DeKalb County Historic Preservation Commission

Staff Report

H. 334 Durand Falls, Juan Ramirez. Replace roof, door, and windows, and construct a rear addition and a second story addition on a nonhistoric house. **1247500**

PROJECT NAME: NEW ADDITION & RENOVATION FAWCETT RESIDENCE

A3.02

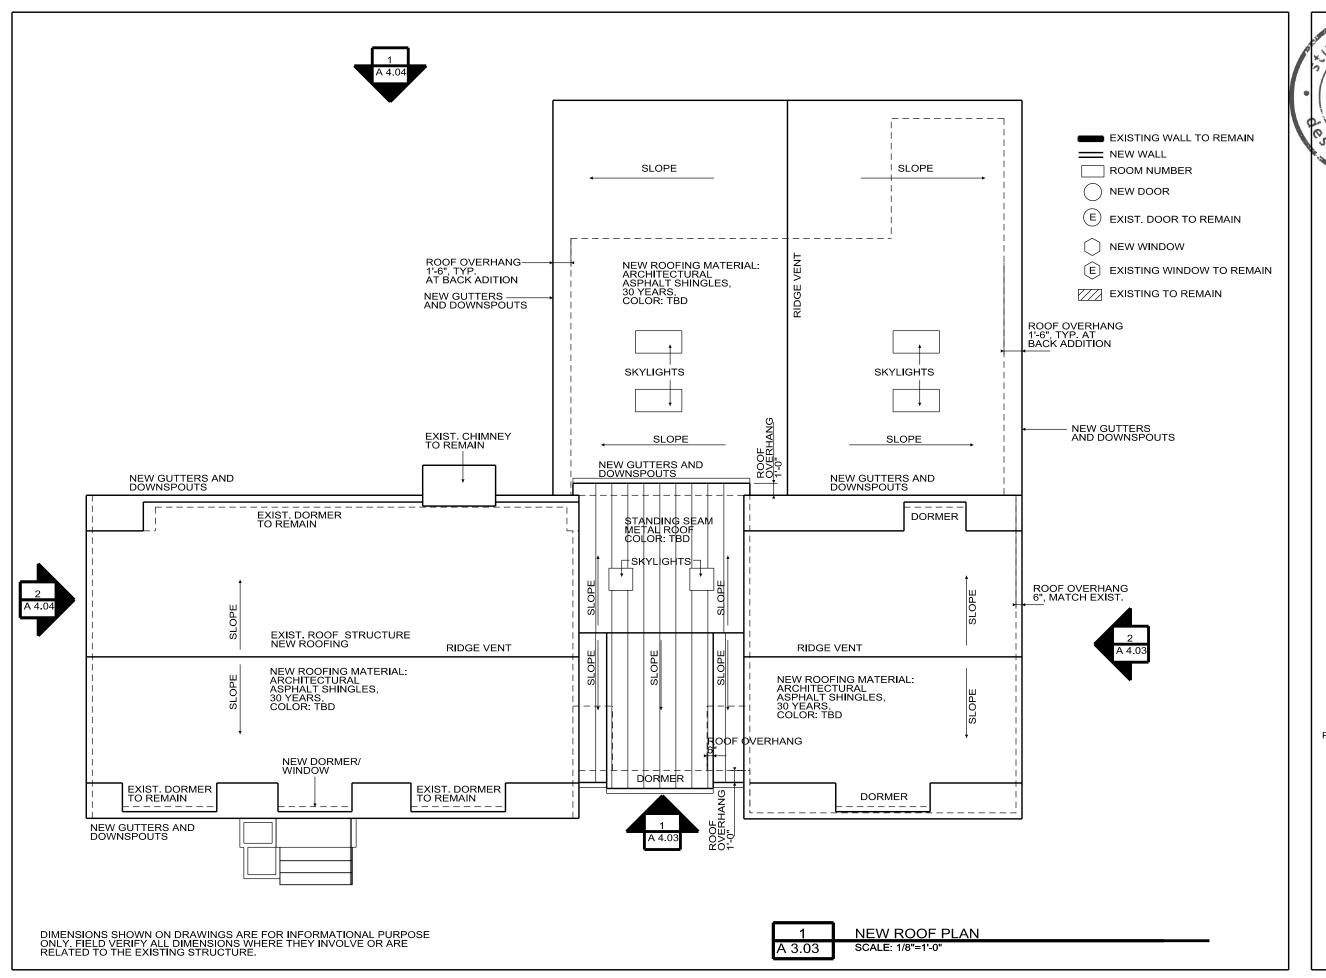
The wood deck was built as a temporary structure during Covid and will be removed as it is completely rotten. A picture of the wooden deck has been added to A 9.02.
- 6. Is the hyphen section between the main structure of the house and the garage recessed from the front façade of the house and garage? If so, can you provide information on the distance in which the hyphen is recessed and images or drawings to show the recess of the hyphen from the main house and garage with the second story addition?

Yes, the hyphen section between the main structure and the garage is recessed. Dimensions have been added to A 3.01 showing the existing recess on Level 1 to remain. Dimensions have also been added to A 3.02 showing that the second floor addition will follow the same recess.
